HISTORIC AND DESIGN REVIEW COMMISSION

HDRC CASE NO: 2020-525
ADDRESS: 831 LAMAR ST
LEGAL DESCRIPTION: NCB 1368 BLK 5 LOT 21
ZONING: R-6, H
CITY COUNCIL DIST.: 2
DISTRICT: Dignowity Hill Historic District
APPLICANT: Ron Hill
OWNER: Ron Hill
TYPE OF WORK: Front yard fence
APPLICATION RECEIVED: November 20, 2020
60-DAY REVIEW: Not applicable due to City Council Emergency Orders
CASE MANAGER: Huy Pham

The applicant is requesting a Certificate of Appropriateness for approval to install a metal cattle panel front yard fence and gate.

Photographs	<div>November 16, 2020 at 8:45 AM 827 Lamar St San Antonio TX 78202 United States</div> 
-------------	--

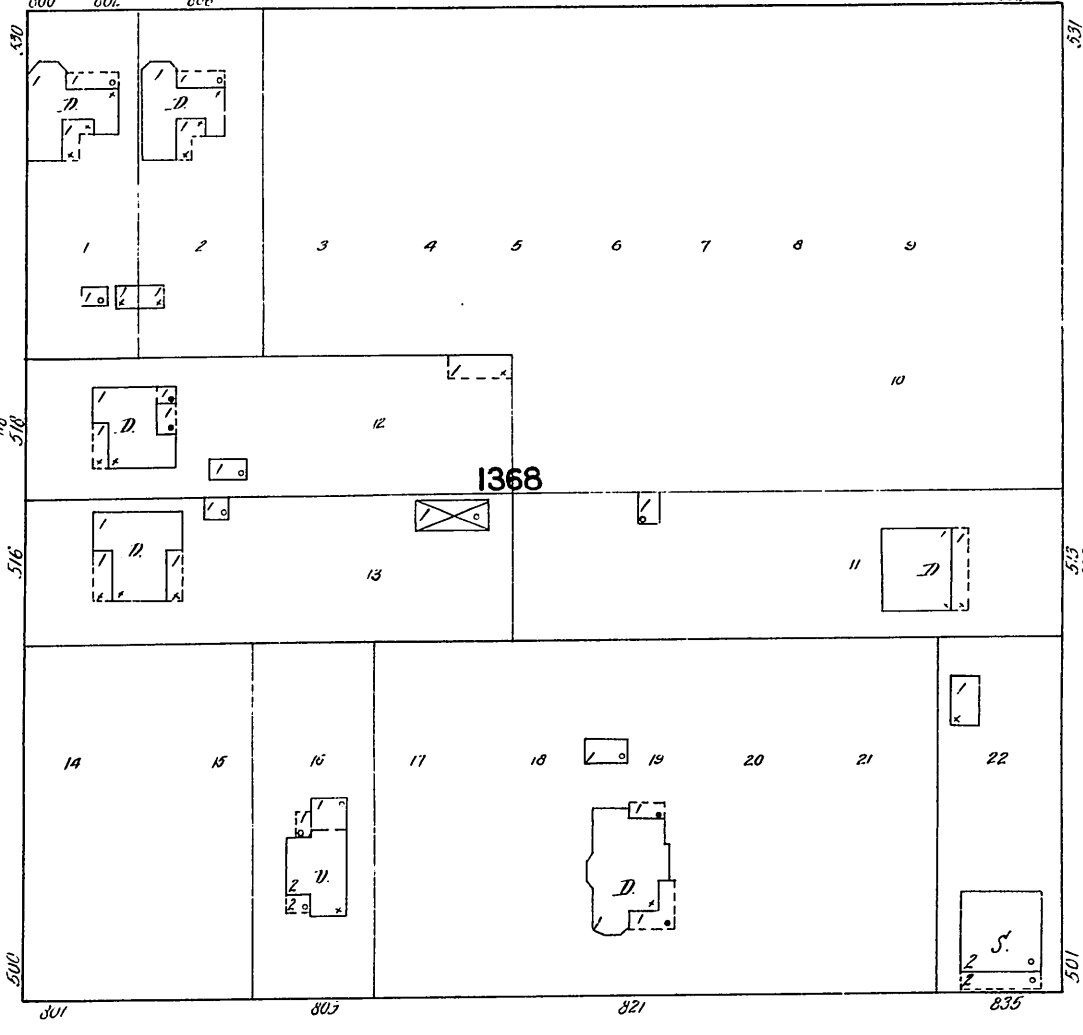
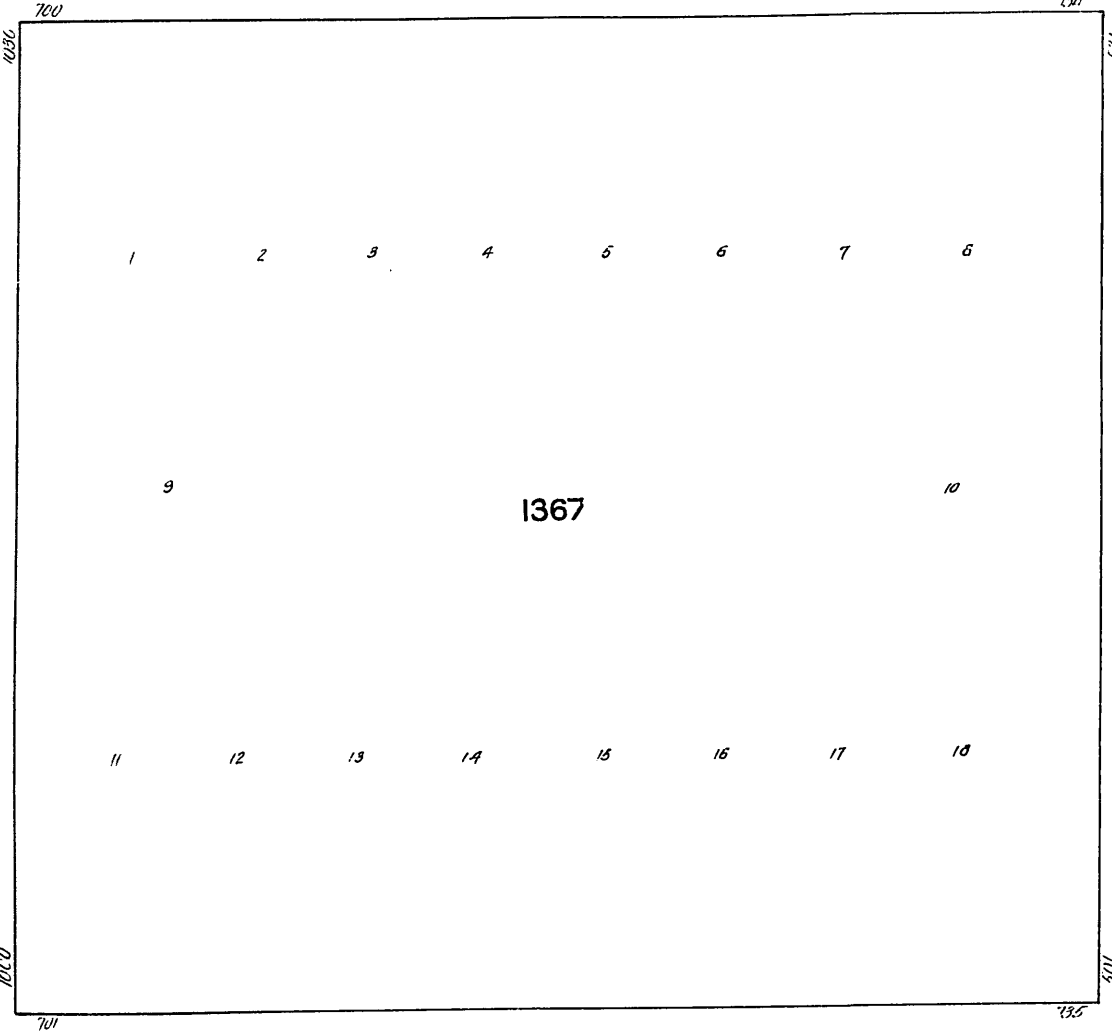
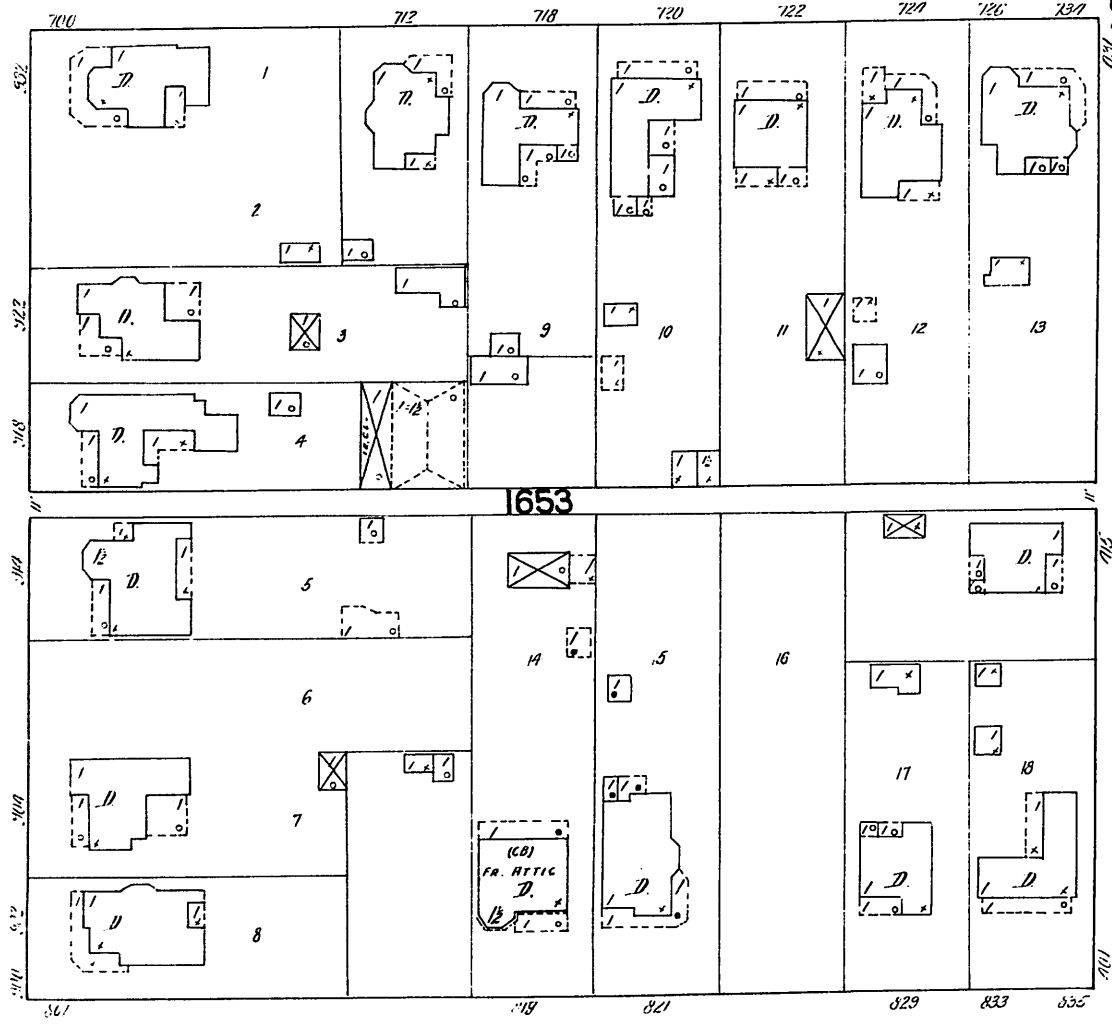
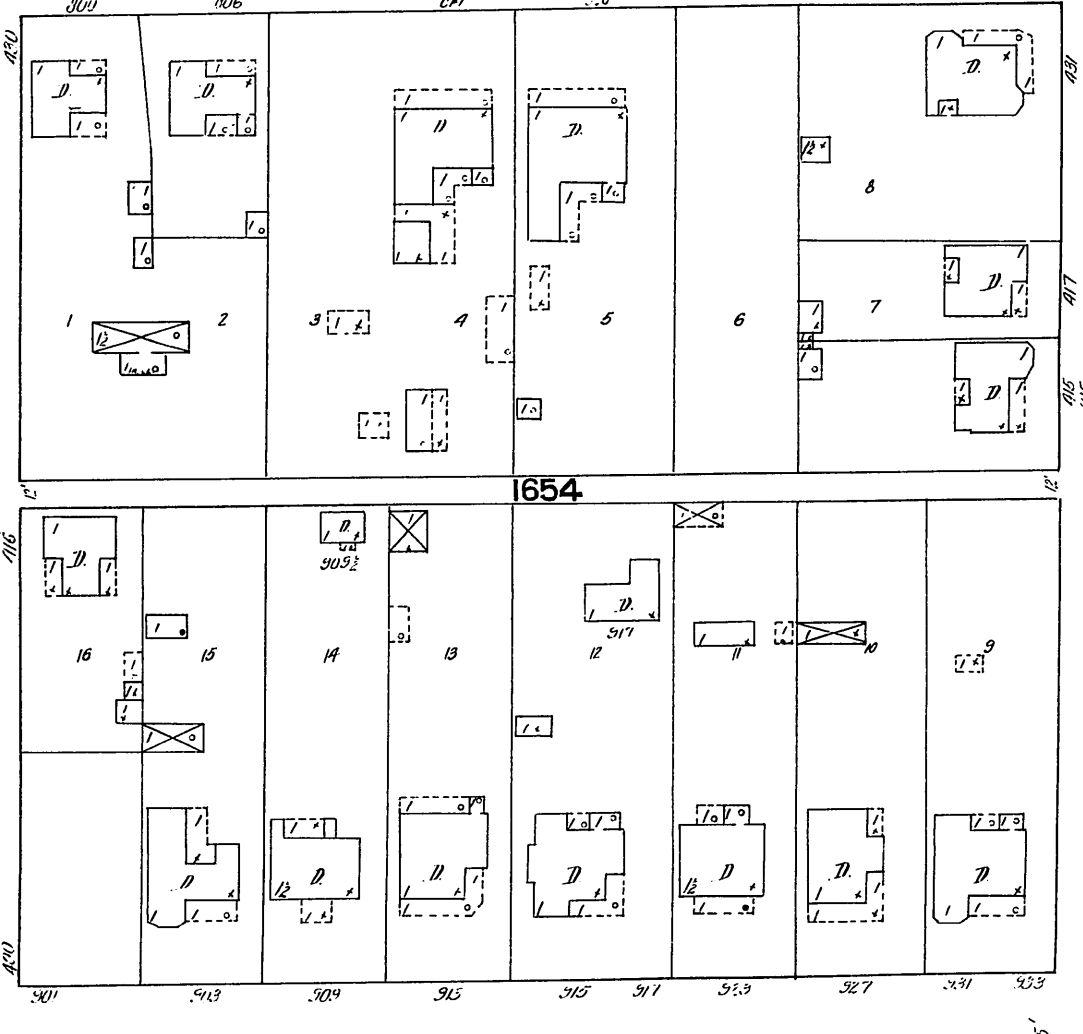
- b. COMPLIANCE – On a site visit on November 16, 2020, staff found that a wood-framed cattle panel fence with a front driveway gate was installed prior to the issuance a Certificate of Appropriateness and permit. The property owner was cooperative and submitted an application of November 16, 2020, to be heard at the next available hearing.

Date	11/16/2020
Time	08:55 AM (-6 GMT)
Context	citizen report
Present Staff	Huy Pham
Present Individuals	Neighbor
Types of Work Observed	Site Elements
Amount of Work Completed	Completed
Description of work	Metal framed cattle panel fence with front driveway gate
Description of interaction	Staff spoke to owner who explained that the fence contractors said they revived permits and approval. Staff explained that no application has been submitted or approved. The owner was cooperative and committed to follow up.
